City of Plymouth Planning Commission

Regular Meeting Agenda

THE VILLAGER
PUD24-02 **900 Starkweather**
Revised Preliminary PUD
PC Mtg 5/14/25 PH

Applicant:	Califur, LLC 23500 Ford Road, Suite 4 Dearborn Heights, MI 48127 Contact: Justin Booth
Project Name:	The Villager PUD
Plan Date:	November 20, 2024
Latest Revision:	February 7, 2025
Location:	900 Starkweather Street, Plymouth, MI (East side of Starkweather, just south of the railroad tracks, across from 885 Starkweather)
Zoning:	MU, Mixed Use
Action Requested:	Preliminary PUD Approval

Proposed Renovation

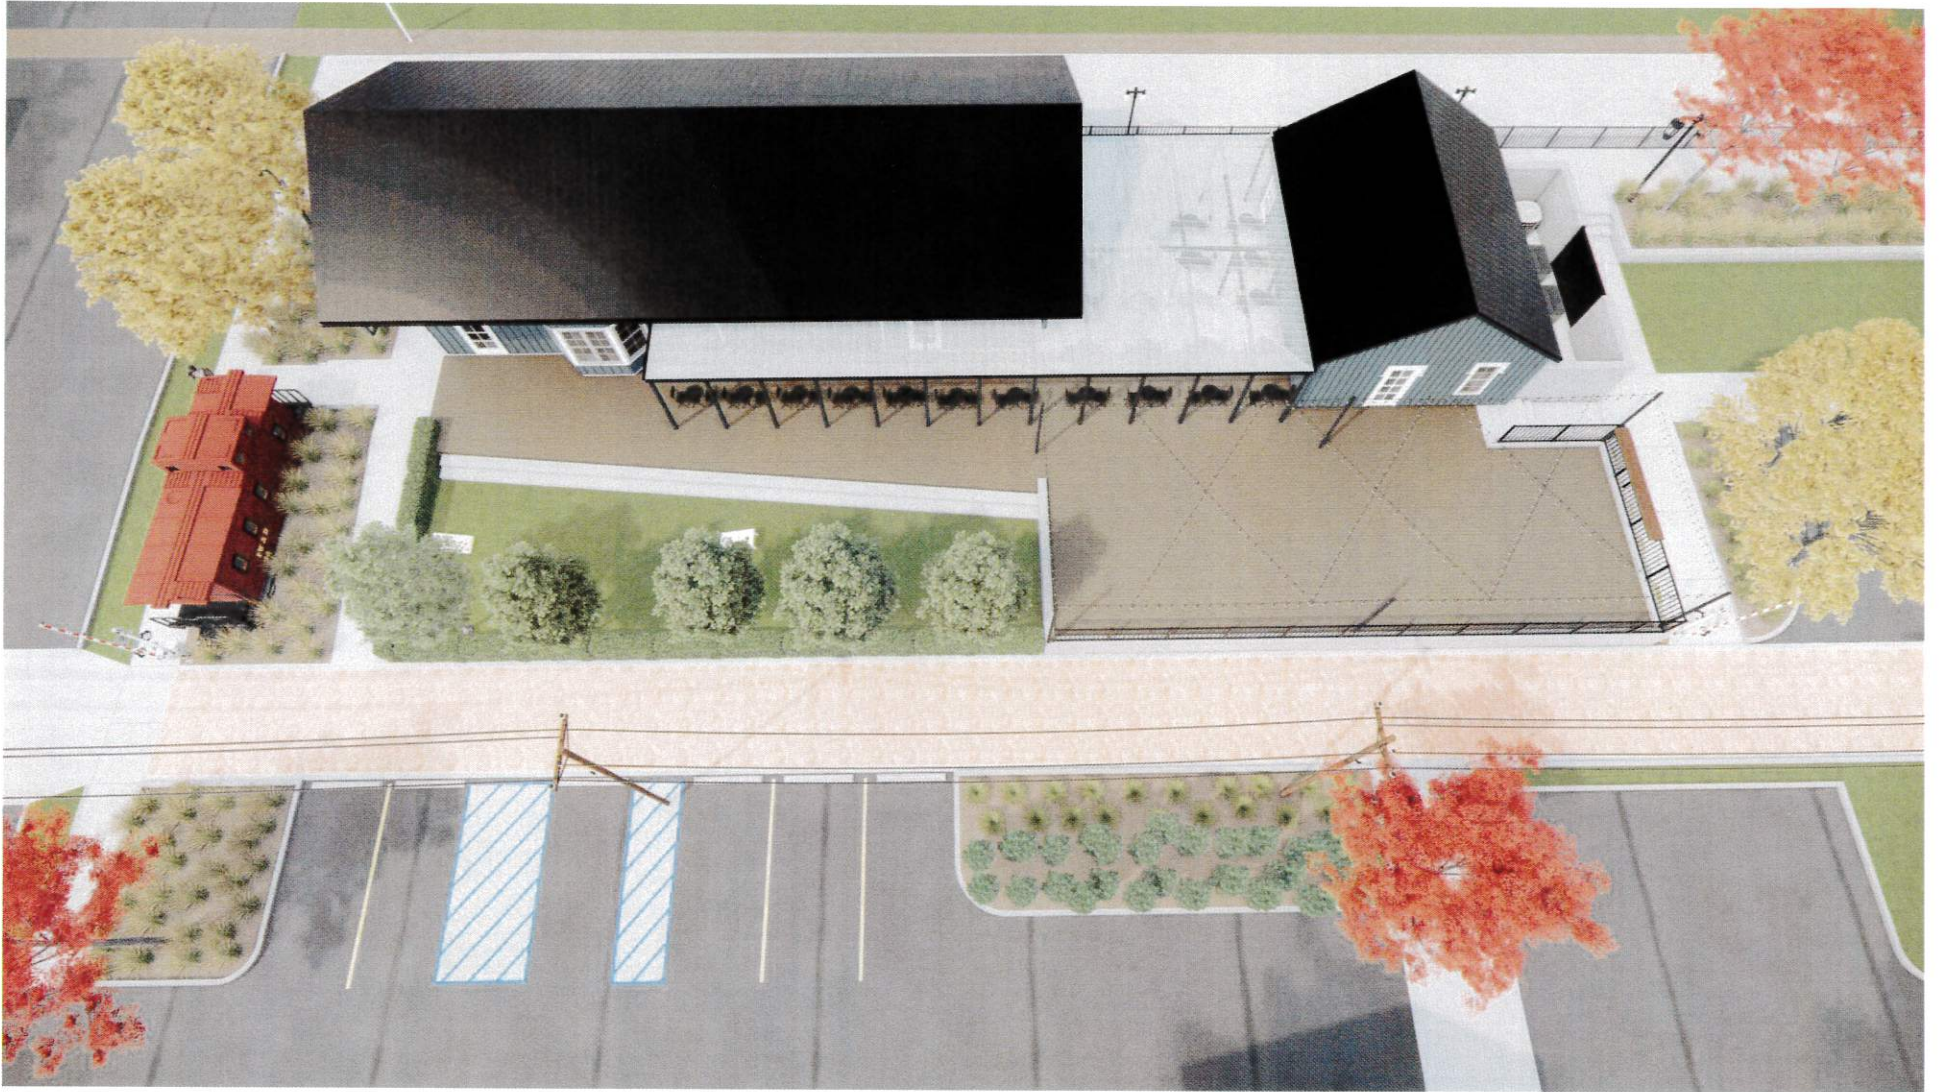
- Front (west) Façade: The proposed faux window near the park on the front façade mirrors the configuration of a window from the original structure, but has been modified to a pedestrian-friendly height—an improvement that enhances the street-level experience and supports a walkable, engaging environment. Additionally, the applicant has proposed signage that reflects the historic character of the original station, with the word “Villager” placed at a similarly elevated position as the original “Plymouth” signage.

- Patio (south) Façade: The historic photographs do not show this façade of the building. On the new design, the renderings show windows and window hoods that align with the historical character of the building. A bay window has been shifted from the north façade to this façade. This façade also has a new window area that could also fully open (possibly like a garage door). This window and whether it is operational should be described. Elevations and floor plans are required at Final PUD review.

- Railroad Tracks (north) Façade: The historic building had three tall windows, and a bay window feature. We assume the bay was the ticket window. The new design will not have a bay, but two additional windows, with hoods, have been added to allow light into the building.

1. *Does the large window on the patio (south) façade operate? If so, please explain.*
2. *Recommend Planning Commission condition Preliminary PUD Plan approval on the applicant supplying elevations and floor plans of the proposed building renovations at Final PUD Plan review.*

- A. Train Depot Building. Recommend Planning Commission condition Preliminary PUD Plan approval on the applicant supplying elevations and floor plans of the proposed building renovations at Final PUD Plan review.
